D1.2 Comments Discussion Document

**Chris DiMinico
MC Communications/
LEONI Cables & Systems
cdiminico@ieee.org**

Comment#228 D1,2

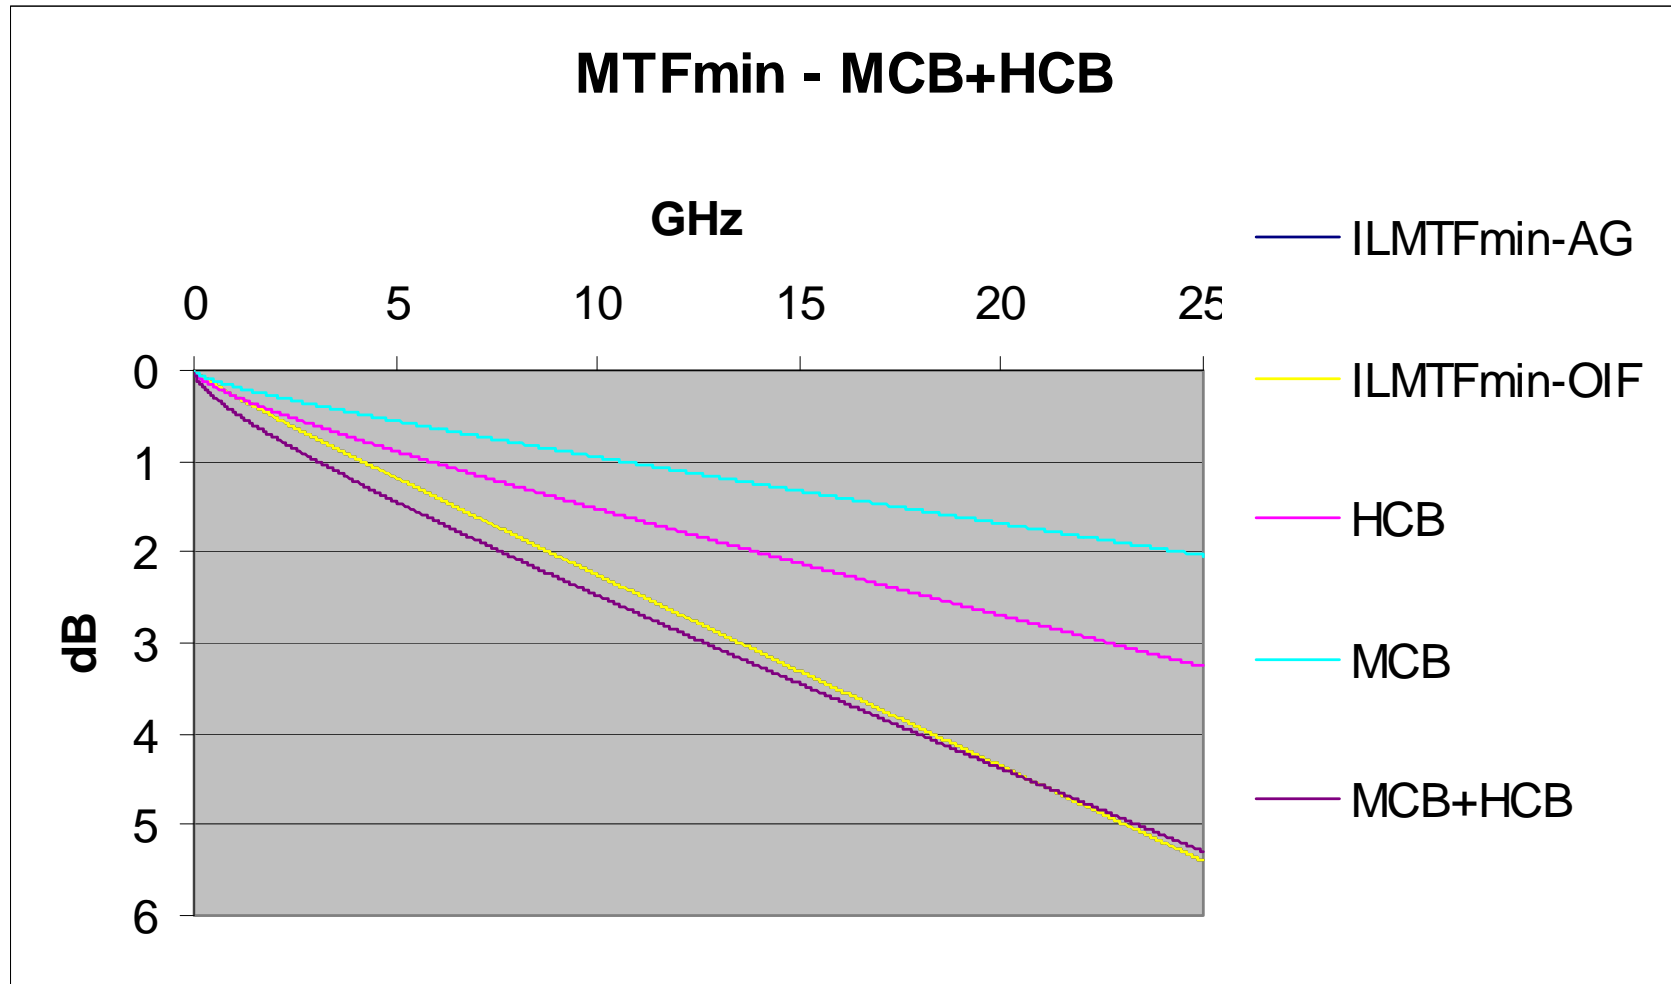
Mated HCB-MCB SDD21, $SDD12 < -0.08\sqrt{f} - 0.2*f$ dB for $f < 28$ GHz

Mated HCB-MCB SDD21, $SDD12 > -0.12 - 0.475\sqrt{f} - 0.221*f$ dB for $f < 14$ GHz

Mated HCB-MCB SDD21, $SDD12 > 4.25 - 0.66*f$ dB for $14 \text{ GHz} < f < 28 \text{ GHz}$

$ILMTF_{min} = (0.08*\sqrt{f} + 0.2*f)$ for 0.01 to 25.78 GHz

$ILMTF_{max} = (-0.114 + 0.45*\sqrt{f} + 0.21*f)$ for 0.01 to 14 GHz
 $= 4.5 - 0.66*f$ for 14 to 25.78 GHz

92.10.4 Cable assembly return loss

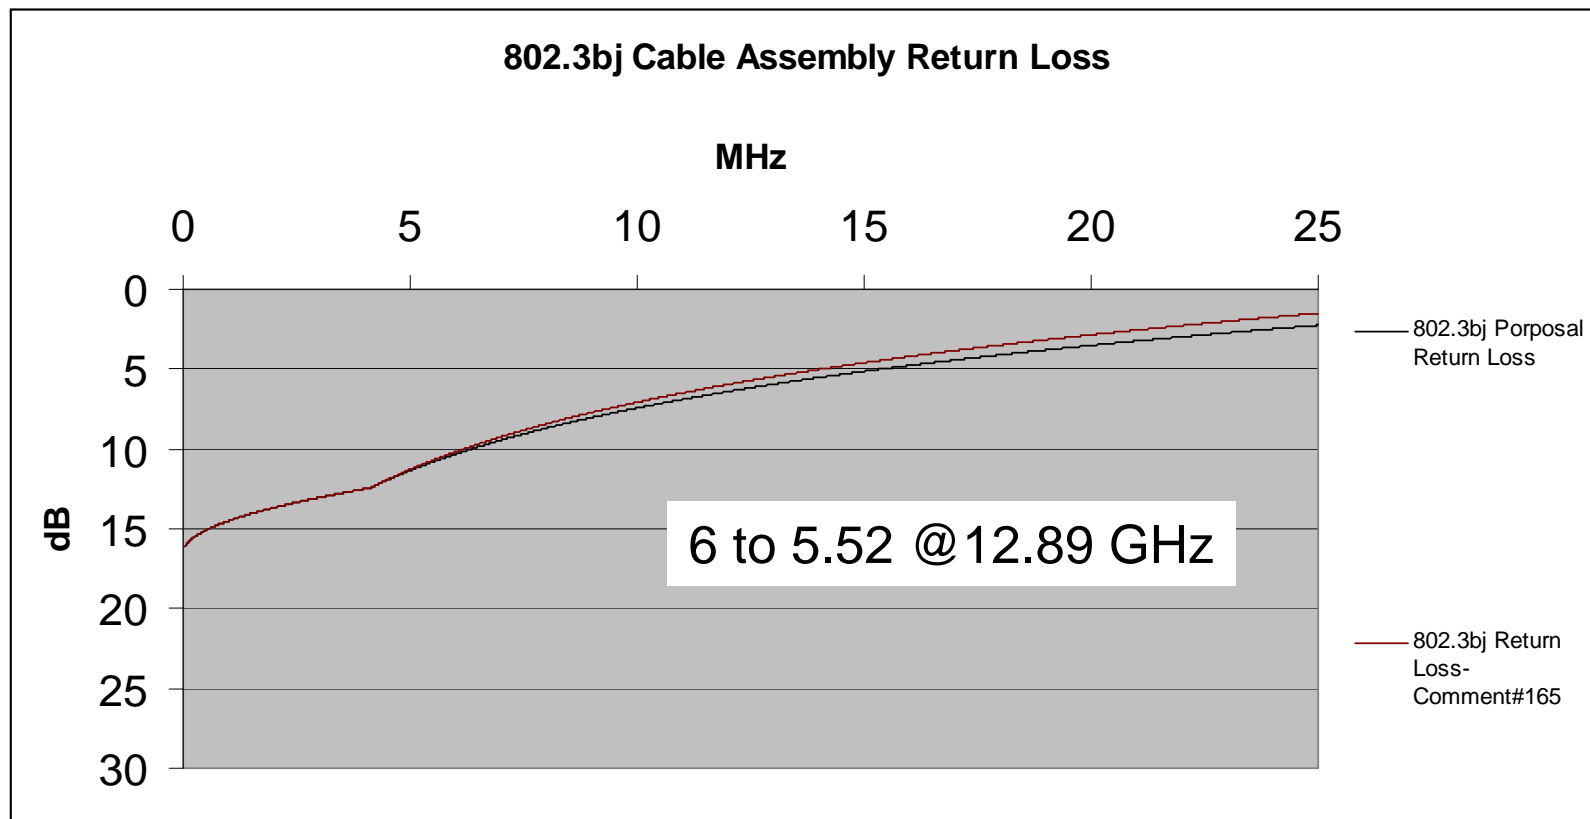
CI 92 SC 10 P167 L 4648 # 165
Bugg, Mark Molex
Comment Type TR Comment Status X
Modify Eqn 92-14 based on measured data
Suggested Remedy
Change Equation 92-14 from
10.80-13log(f/5.5)
to
10.70-14LOG(f/5.5)
Proposed Response Response Status O

92.8.3.5 Insertion loss TP0 to TP2 or TP3 to TP5

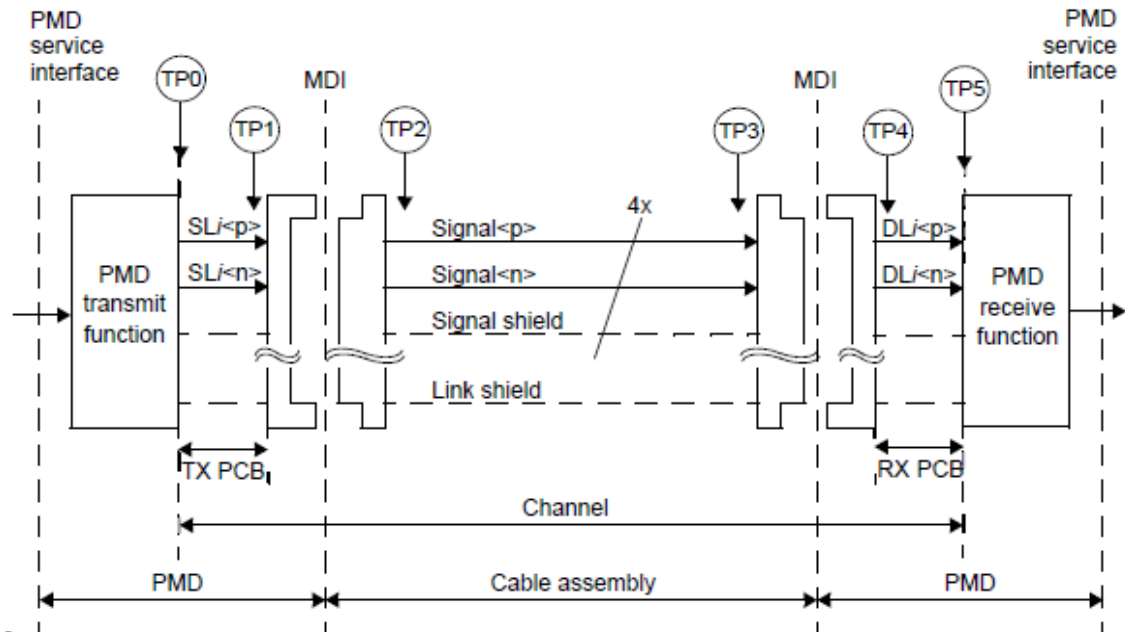
Equation 92A-1 is not consistant with the TP0 to TP2 loss where coefficent SQRT(F) and f are about the same, but equation 92A-1 linear term is twice the SQRT term. Propose to use scale version of equation 92-4

If equation 92-4 is multiplied by 0.7 then loss at 12.89 Ghz will be 6.8 dB
 IL_Prop=0.0565+0.4263*sqrt(f)+0.4045*f where f is from 0.01 to 18.75 GHz

TP0-TP2 includes connector which will add to sqrt(f) loss
 connector IL does not scale linearly

92A-1 is PCB IL

Figure 92–2—100GBASE-CR4 link (one direction is illustrated)

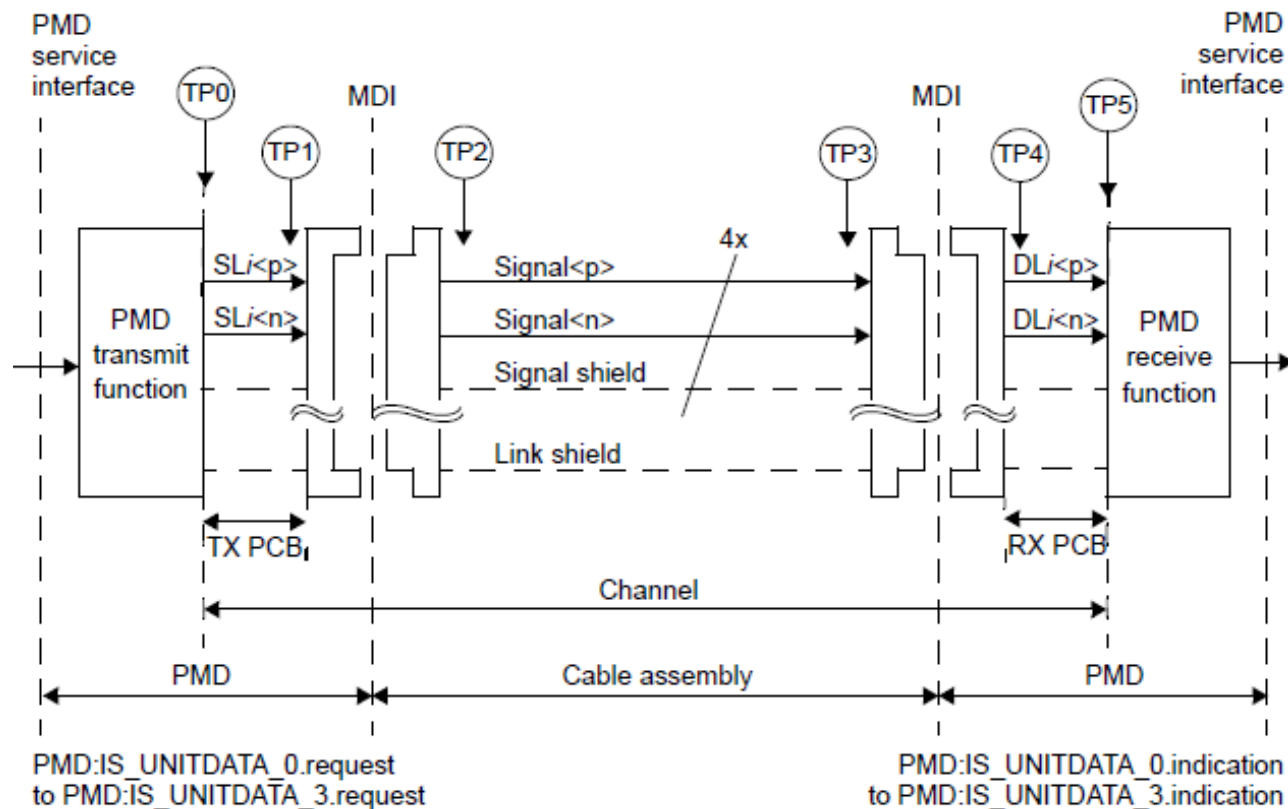
<i>Cl</i> 92A	<i>SC</i> 92A.8	<i>P</i> 285	<i>L</i> 29	# 64
DiMinico, Christopher		MC Communications		
<i>Comment Type</i>	<i>TR</i>	<i>Comment Status</i>	<i>D</i>	
92A.8 Channel integrated crosstalk noise (ICN) includes TBDs; Equation 92A-7 and Figure 92A-3				
<i>SuggestedRemedy</i>				
diminico_1112.pdf provides Equation 92A-7 to be used for Figure 92A-3.				
<i>Proposed Response</i>		<i>Response Status</i>	<i>W</i>	
PROPOSED ACCEPT.				
Use suggested remedy

The TBD for channel ICN has existed for multiple drafts. A proposal to bound ICN utilizing COM has been suggested but not completed. Considering COM will be used to bound ICN a recommendation on ICN may be useful but not necessary.

Proposed response: Replace this subclause with a recommendation to meet the Channel Operating Margin (COM) between TP0 and TP5.

CI 92 SC 92.10.2 P 165 L 33 # 314
 Dudek, Mike QLogic

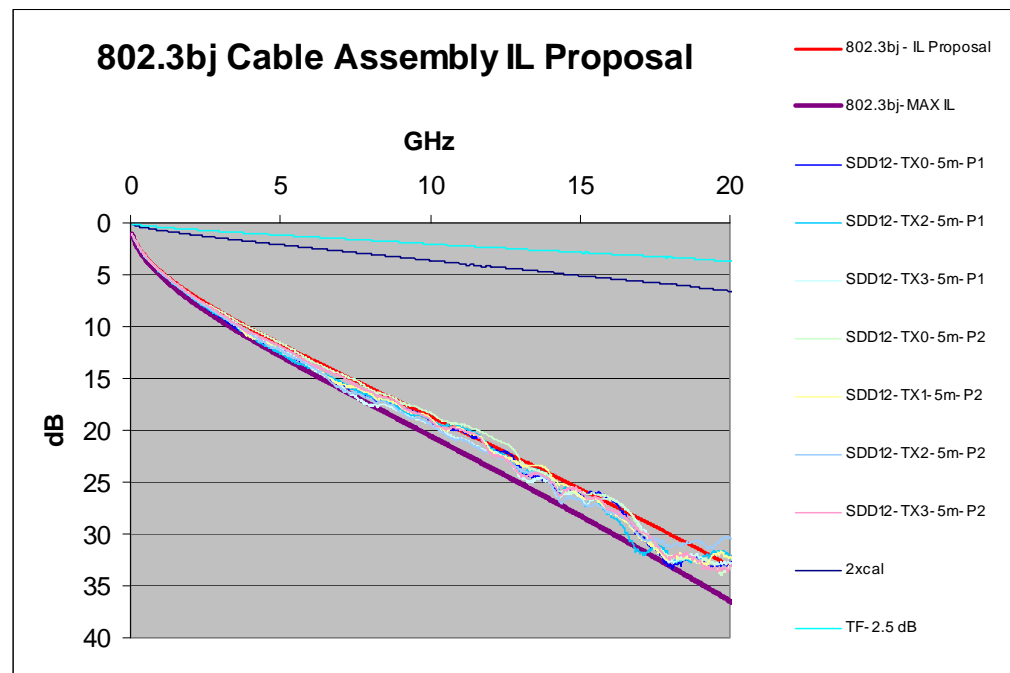
Comment Type 0.70 Comment Status D
 Having these coefficients exactly matching the maximum loss at Nyquist heavily constrains the parameters so that it is likely that many channels that pass the maximum loss at Nyquist will be filtered out by other of these filter parameters. (It also removes the need for the footnote which is deleted if the suggested remedy is not adopted)

Suggested Remedy
 Increase the maximum insertion loss parameters by 20%.

Proposed Response Response Status W
 PROPOSED REJECT.

See diminico_1112.pdf for development of cable assembly insertion loss.

The max loss is a fit to the envelope of the worse case of all the measurements at each frequency...including ILD peaks. The fitting coefficients to any of the individual losses (falling under the max loss) will be less than the values of the fitted coefficients of the max loss.
